To: Honorable Mayor Patrick Collins and Members of the City Council
From: Connor White, Planner II
Subject: PUDC-25-32 / Trailhead Estates 1st Filling / Final Plat
Date: April 14, 2025

FINAL PLAT FOR TRAIL HEAD ESTATES 1st FILING

CITY OF CHEYENNE PLANNING COMMISSION
APRIL 7, 2025
STAFF REPORT

FILE: PUDC-25-32: Trailhead Estates, 1st Filing (Expedited Review)

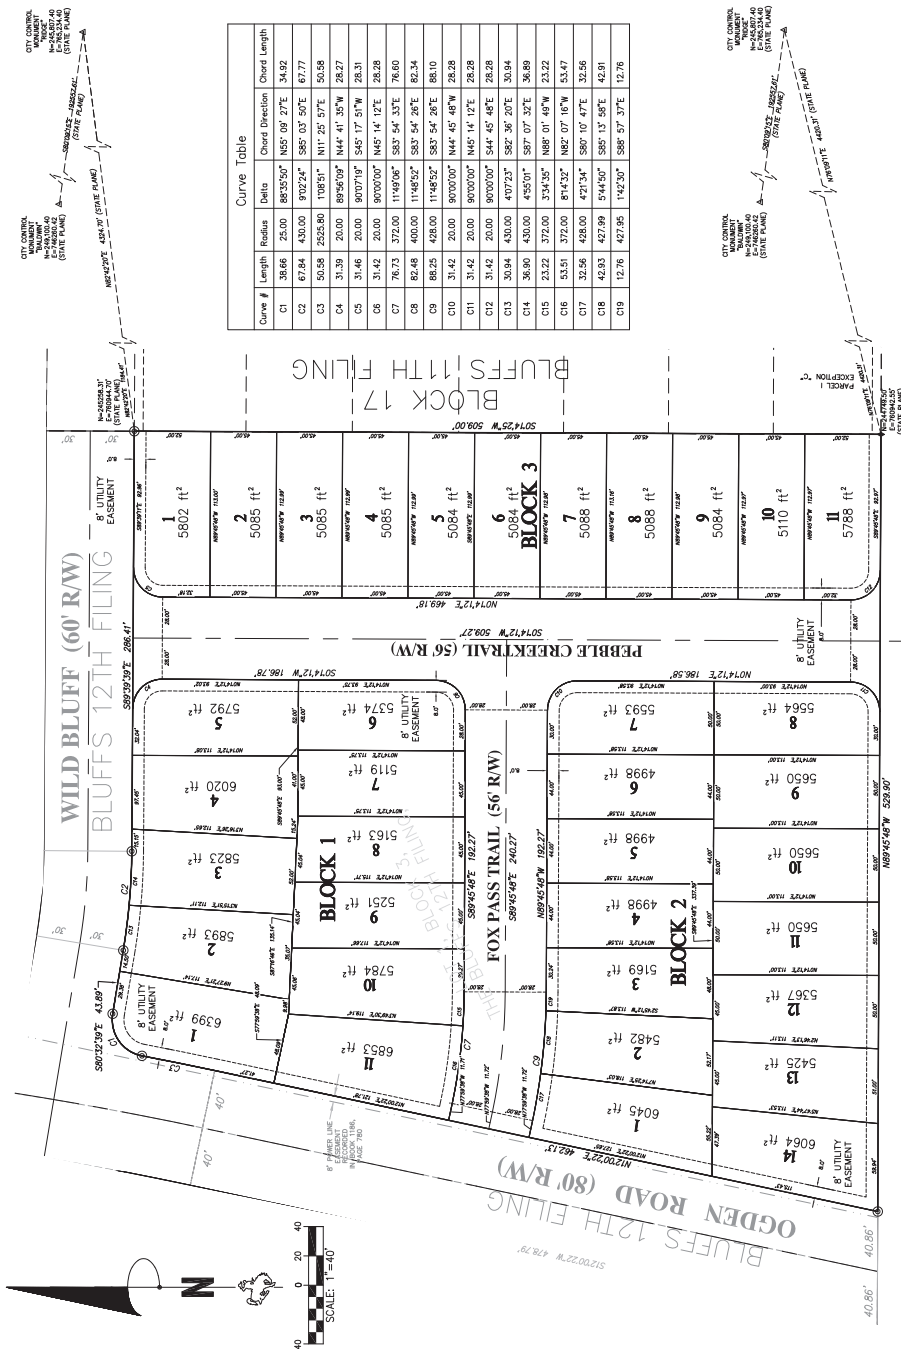
Through staffs review the approval block needs to be updated to state 'approved by Planning Commission' not 'approved by Director'. The corner of Lot 14, Block 2 needs to be adjusted to have a radius. Fawn Pass Trail needs to be renamed as there is already a Fawn Pass in the County. There are also minor technical corrections that need to be corrected.

1. Update the approval block to state 'approved by Planning Commission'.
2. Update the corner of Lot 14, Block 2 to have a radius.
3. Rename Fawn Pass Trail.
4. Make minor technical corrections.
